GE Hitachi Nuclear Energy

Subject: Response to Portion of NRC RAI Letter No. 166 Related to ESBWR Design Certification Application - DCD Tier 2 Section 3.8 – Seismic Category I Structures; RAI Number 3.8-96, Supplement 3

**Response to Portion of NRC RAI Letter Nos. 166
Related to ESBWR Design Certification Application**

RAI Number 3.8-96 S03

Figure 3.8-96(1) Horizontal Forces in Sliding Evaluation (Basemat Plan)

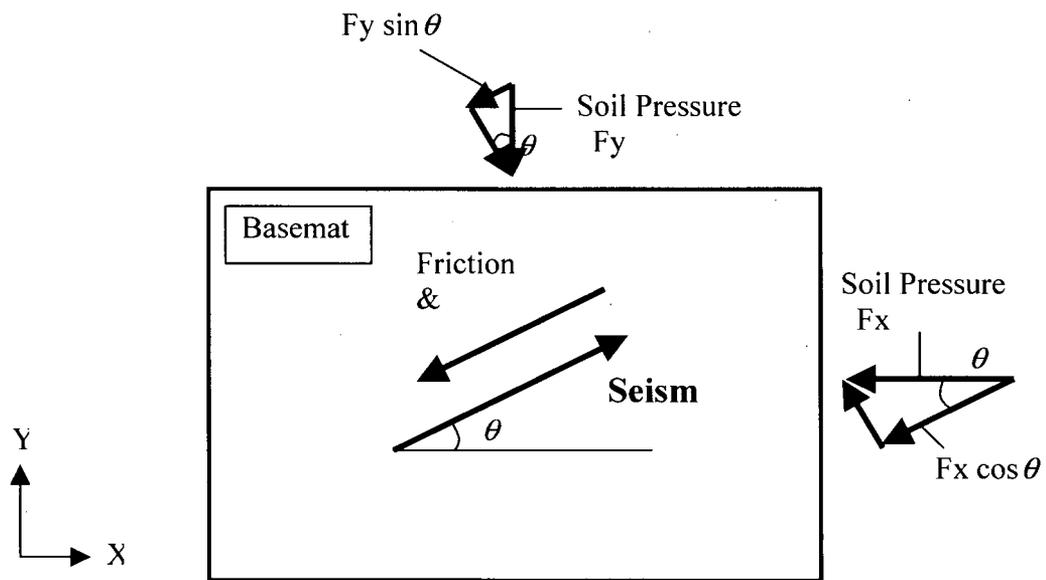
- (9) *As noted in the staff's prior assessment of GEH RAI 3.8-96, Supplement 2, response, the traditional method for evaluating the stability (sliding and overturning) of nuclear plant structures in accordance with SRP 3.8 is to perform two separate 2-D evaluations, one for the N-S direction and one for the E-W direction. The minimum vertical downward load (deadweight minus upward buoyancy force minus upward vertical seismic force) is considered separately with the N-S horizontal seismic force and with the E-W horizontal seismic force.*

In calculating the total upward vertical seismic force, the total N-S horizontal seismic force, and the total E-W horizontal seismic force at the soil/foundation interface, it is acceptable to use either SRSS or 100-40-40 (as defined in RG 1.92, Rev. 2) to combine the individual RESPONSES from response spectrum analyses for the 3 directions of seismic loading. Thus, the SRSS or the 100-40-40 methods are used only to determine the individual total structural response in a given direction (e.g., total shear force in N-S direction) from the individual collinear responses due to each of the three perpendicular seismic excitations (i.e., N-S shear force due to N-S earthquake, N-S shear force due to E-W earthquake, and N-S shear force due to vertical earthquake). The approach GEH is using does not follow this method, but instead combines non-collinear structural responses (i.e., N-S shear force, E-W shear force, and vertical force) following the 100-40-40 method, which is unacceptable. In lieu of this, the results from a 3-D time history analysis using statistically independent inputs can be used, to search the time history response for the worst case combination of vertical and horizontal seismic responses, which minimize the sliding and overturning factors of safety when combined with deadweight and upward buoyancy force.

Applied horizontal seismic forces and sliding resistances are schematically shown in Figure 3.8-96(1). Among the resistances, the basemat bottom friction and cohesion act in the direction of the resultant seismic force and their magnitudes are the same as those in the 2-dimensional evaluation.

Figure 3G.4-11. ~~Shear Keys and Concrete Backfill in Sliding Evaluation~~ Deleted

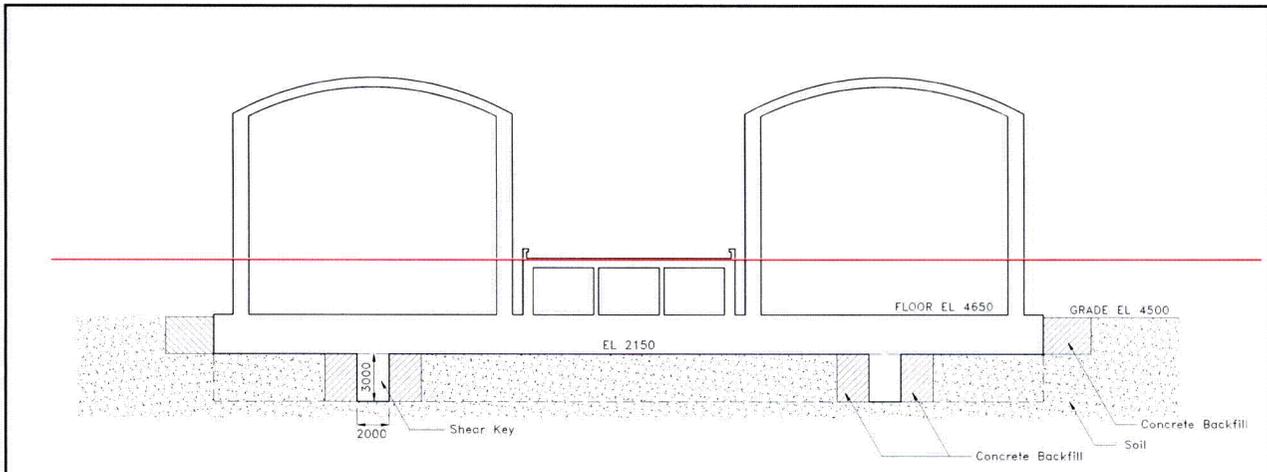
- (8) Describe the COL requirements for the backfill material for the gap shown in Figures 3G.1-65 and 3G.2-15. Will the backfill material be required to have a stiffness defined by its shear wave velocity which is at least equal to the shear wave velocity of the surrounding insitu soil? If*

The factors of safety against overturning, sliding and floatation are given in Table 3G.4-22. All of these meet the acceptance criteria given in Table 3.8-14. Shear keys under the basemat shown in Figure 3G.4-1 are used to resist sliding. ~~In addition, the gap between the basemat and excavated soil is backfilled with concrete up to the grade level as shown in Figure 3G.4-11.~~

Note: ~~Excavation and backfill method is determined considering actual site conditions.~~
